## LOSS CONTROL SERVICES

January 22, 2015

A hazard recognition evaluation survey was conducted at Metro's Multnomah Channel North and South Water Control Structures. The purpose of the evaluation was to determine if the process of adjusting the weir height in the North and South water control structures that separate the channel from adjacent wetlands presents employee workplace and "Permit Required" confined space hazards.

### Exhibits

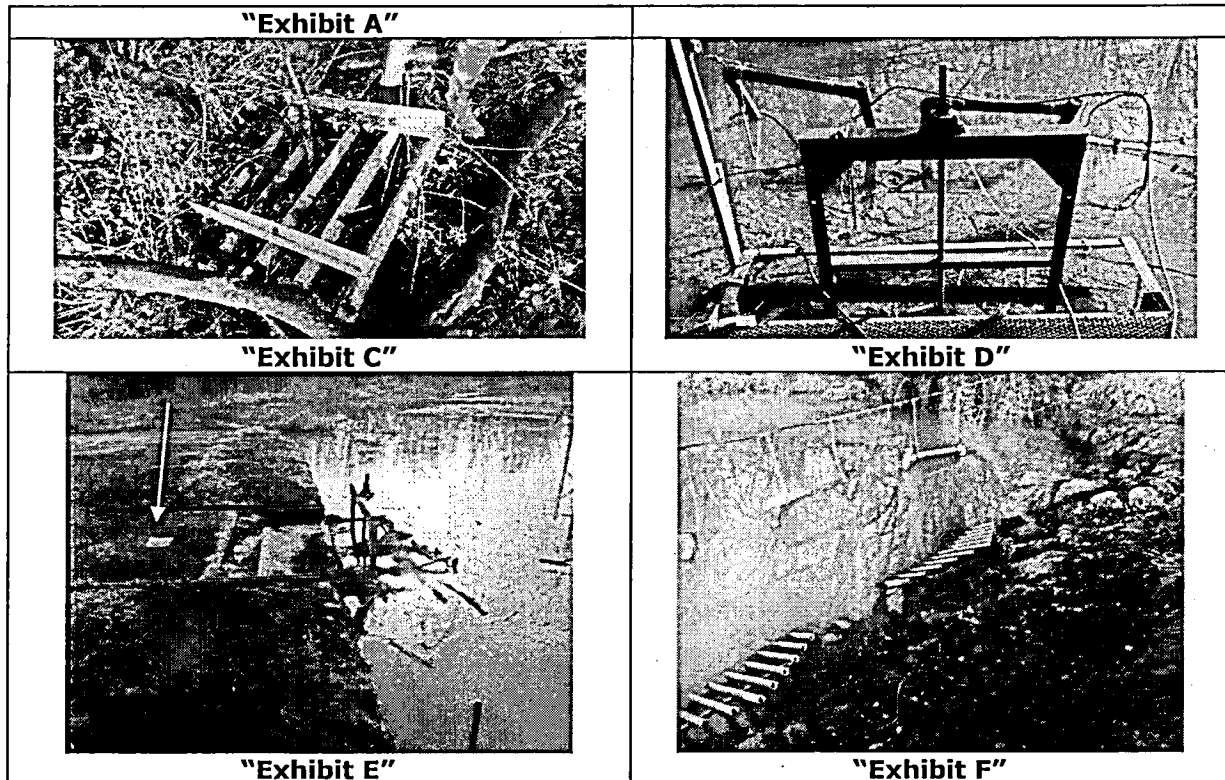
1. To install or remove the stop-logs employees must bend over and kneel down on the riser's steel grate covers in an ergonomically stressful position that increases their chance of experiencing a back injury and puts their reaching arms in ergonomically stressful "Red Zone" postures. The task also increases their chance of falling into the water, getting entangled in debris, developing hypothermia in the cold water and possibly drowning before they can be assisted by a co-workers. See exhibit B.

2. The wetlands sides of both the North and South channel's gates are unprotected by standard guardrails increasing the potential that an employee may fall into the water during routine servicing of the gates. See exhibits A & E.

4. The debris grates on the discharge or channel side of the water control structures are stuck, bolted or welded in place. The structure's plans call for hinged gates but the hinges have long since rusted tight preventing the gates from functioning as designed. Access holes have been cut into the grates (South gate observed) in order to allow employee entry into to pipes for access to the tide gates and stop-logs. It also allows debris to enter the inverted pipes during high tides further increasing the number of debris clean-outs required to be done by staff. See exhibits C & F.

5. One thousand pound capacity rotating davit lift arms, equipped with a hand operated winches, were at one time available to remove debris and stop-logs from the risers but have since been damaged by vandals and removed from service requiring employees to manually do the work. The base holes are still available for use on the wetlands side of the structures but were not constructed for use on the channel sides. See exhibit E for base holes.

6. The manual opening and closing of the slide gates to drawdown the wetlands takes an employee approximately one hour of turning a ring handle in an ergonomically stressful "High Red Zone" posture that increases ergonomic stressors to their shoulders. In most cases the worm gears are rusted increasing the force necessary to raise or lower the slide gates. See exhibit D.

1. Install standard guardrails on the wetlands sides of both water control structures as a strategy to prevent fall-in water and drowning hazards.
2. At the South structure install a stairway from the road to the riser access area as a strategy to prevent slip and fall related injuries when ascending and descending the slope.

3. Require employees to wear personal flotation devices when servicing the risers as a strategy to help prevent drowning accidents.
4. Reinstall and/or reacquire a 1,000 lb rated rotating davit lift arm with a hand operated winch for use at both water control structures to install or remove heavy stop-logs from the riser channels and as a strategy to prevent manual material handling and laceration injuries.

6. Reinstall the cut-out sections of the debris grates on the channel side of the South water control structure and repair or replace the frozen hinges (on North structure as needed) as a strategy to prevent tidal debris from entering the inverted pipes and reducing the number of required entries. Consider additional study of the task to determine if the area is a "Permit Required" confined space and develop OSHA required entry procedures as needed.

7. Replace the rusted stems (worm gears) on the tide gates or install a gear/power drive unit as a strategy to decrease the force necessary, and resulting ergonomic stressors to the employees, when opening or closing the units.

### Exhibits

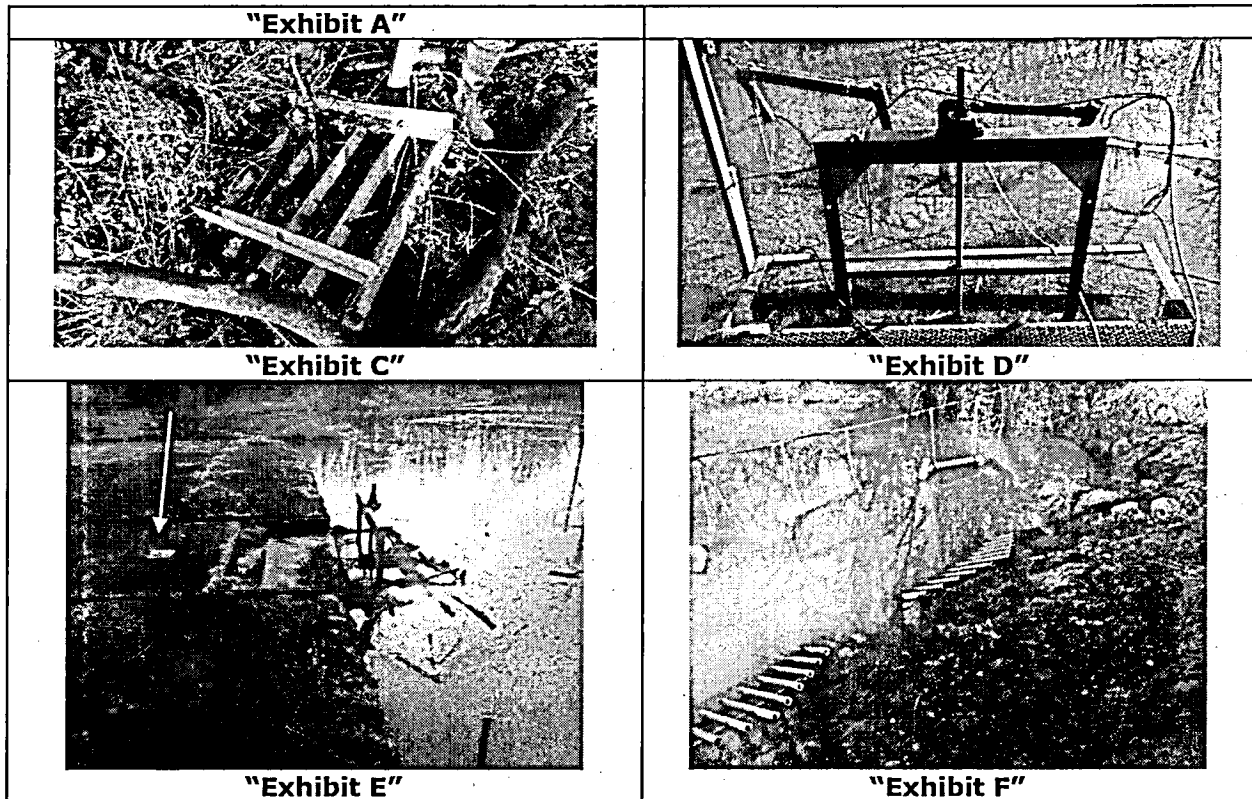
1. To install or remove the stop-logs employees must bend over and kneel down on the riser's steel grate covers in an ergonomically stressful position that increases their chance of experiencing a back injury and puts their reaching arms in ergonomically stressful "Red Zone" postures. The task also increases their chance of falling into the water, getting entangled in debris, developing hypothermia in the cold water and possibly drowning before they can be assisted by a co-workers. See exhibit B.

2. The wetlands sides of both the North and South channel's gates are unprotected by standard guardrails increasing the potential that an employee may fall into the water during routine servicing of the gates. See exhibits A & E.

4. The debris grates on the discharge or channel side of the water control structures are stuck, bolted or welded in place. The structure's plans call for hinged gates but the hinges have long since rusted tight preventing the gates from functioning as designed. Access holes have been cut into the grates (South gate observed) in order to allow employee entry into to pipes for access to the tide gates and stop-logs. It also allows debris to enter the inverted pipes during high tides further increasing the number of debris clean-outs required to be done by staff. See exhibits C & F.

5. One thousand pound capacity rotating davit lift arms, equipped with a hand operated winches, were at one time available to remove debris and stop-logs from the risers but have since been damaged by vandals and removed from service requiring employees to manually do the work. The base holes are still available for use on the wetlands side of the structures but were not constructed for use on the channel sides. See exhibit E for base holes.

6. The manual opening and closing of the slide gates to drawdown the wetlands takes an employee approximately one hour of turning a ring handle in an ergonomically stressful "High Red Zone" posture that increases ergonomic stressors to their shoulders. In most cases the worm gears are rusted increasing the force necessary to raise or lower the slide gates. See exhibit D.

THIS WAS NOT USED PRIOR TO VANDALISM ONE TO CHALLENGES TO TRANSPORTING TO LOCATION + CUMBERSOME FUNCTION.

1. Install standard guardrails on the wetlands sides of both water control structures as a strategy to prevent fall-in water and drowning hazards.
2. At the South structure install a stairway from the road to the riser access area as a strategy to prevent slip and fall related injuries when ascending and descending the slope.

3. Require employees to wear personal flotation devices when servicing the risers as a strategy to help prevent drowning accidents.
4. Reinstall and/or reacquire a 1,000 lb rated rotating davit lift arm with a hand operated winch for use at both water control structures to install or remove heavy stop-logs from the riser channels and as a strategy to prevent manual material handling and laceration injuries.

6. Reinstall the cut-out sections of the debris grates on the channel side of the South water control structure and repair or replace the frozen hinges (on North structure as needed) as a strategy to prevent tidal debris from entering the inverted pipes and reducing the number of required entries. Consider additional study of the task to determine if the area is a "Permit Required" confined space and develop OSHA required entry procedures as needed.

7. Replace the rusted stems (worm gears) on the tide gates or install a gear/power drive unit as a strategy to decrease the force necessary, and resulting ergonomic stressors to the employees, when opening or closing the units.
